CNRO-2004-00045

DOCKET: 52-009

SUBJECT: Response to Request for Additional Environmental Information Related to
Early Site Permit Application (Partial Response No. 2)

ATTACHMENT 1

**THERMAL MONITORING REQUIREMENTS
DISCHARGE PATH LOCATIONS**

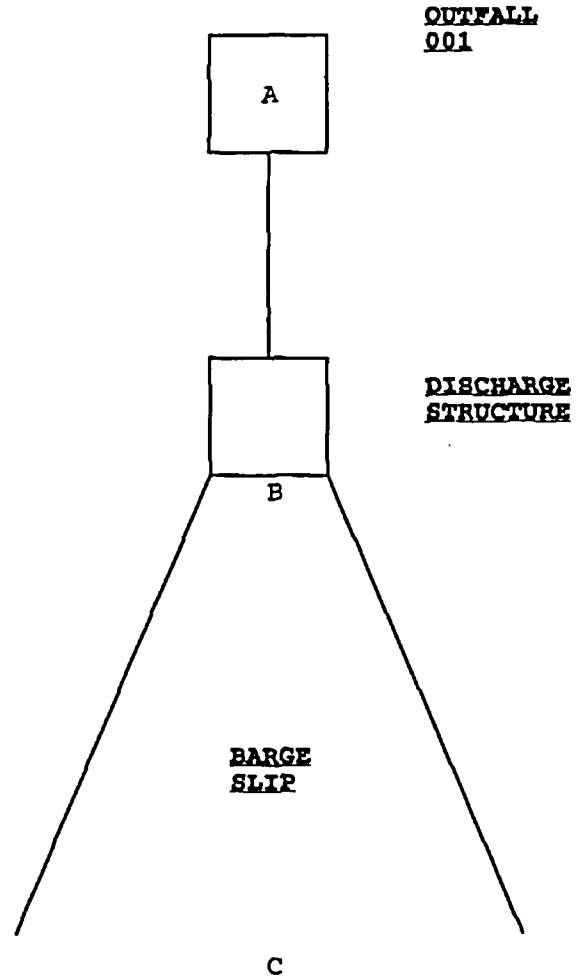
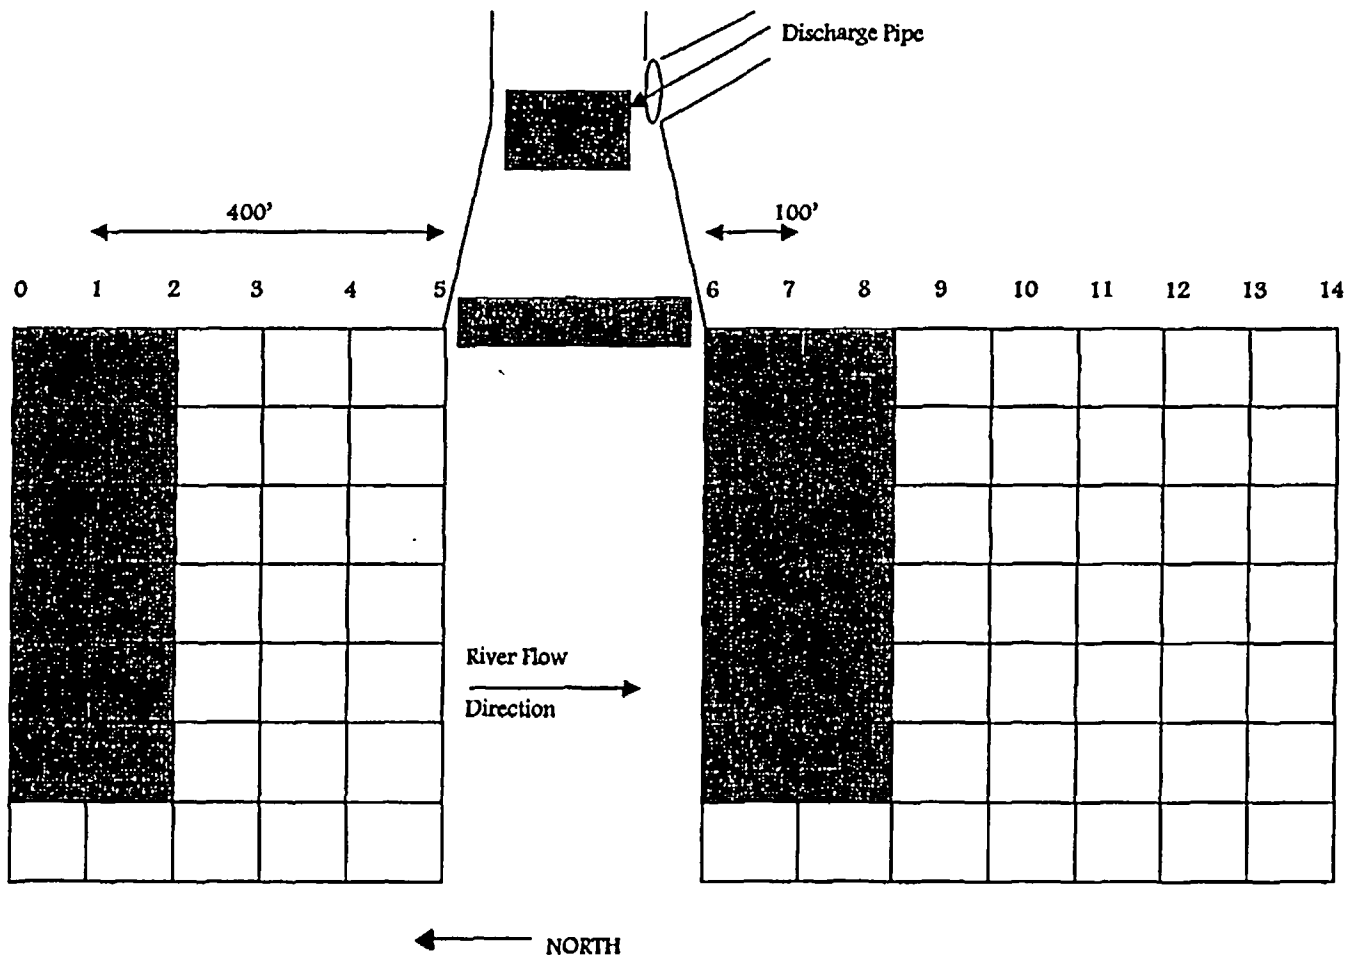
E2.3-11 Section 2.3.1.1.4 (Physical Properties of Surface Waters). Provide a map of the temperature sampling area and sampling plan. Provide NPDES Sampling from January 2002 Reference 2 GGNS Plant Operations Manual, Environmental Instruction-NPDES Sampling, 08-S-09-4, Revision 8, January 14, 2002. Provide Entergy 2002 NPDES renewal Application Attachment C 2001 Winter and Summer Thermal monitoring reports.

E2.3-12 Section 2.3.1.1.4 (Physical Properties of Surface Waters). Provide a legible figure that shows the temperature monitoring locations.

Attachment III to Grand Gulf Nuclear Station (GGNS) Procedure 08-S-09-4, NPDES Sampling (see file 013_Procedure_08_S_09_4.pdf) describes the temperature sampling area and sampling plan and contains two figures that identify the temperature monitoring points (Discharge Path Locations & River Measurement Locations). Below is a brief discussion of the temperature sampling area and sampling plan obtained from the GGNS National Pollutant Discharge Elimination System Permit (NPDES) Number MS0029521 and GGNS Procedure 08-S-09-4, NPDES Sampling.

- Point 1 (Upstream) - approximately 400 feet north of the barge slip outlet and not more than 60 feet from the eastern shoreline, in a depth of water approximately 5 feet.
- Discharge Outlet - at the plant discharge pipe opening into the Barge Slip Outlet.
- Barge Slip Outlet - mouth of the Barge Slip where water enter into the Mississippi River.
- Point 7 (Downstream) – approximately 100 feet south of the mouth of the Barge Slip in the mixing zone and not more than 60 feet from the eastern shoreline, in a depth of water approximately 5 feet.
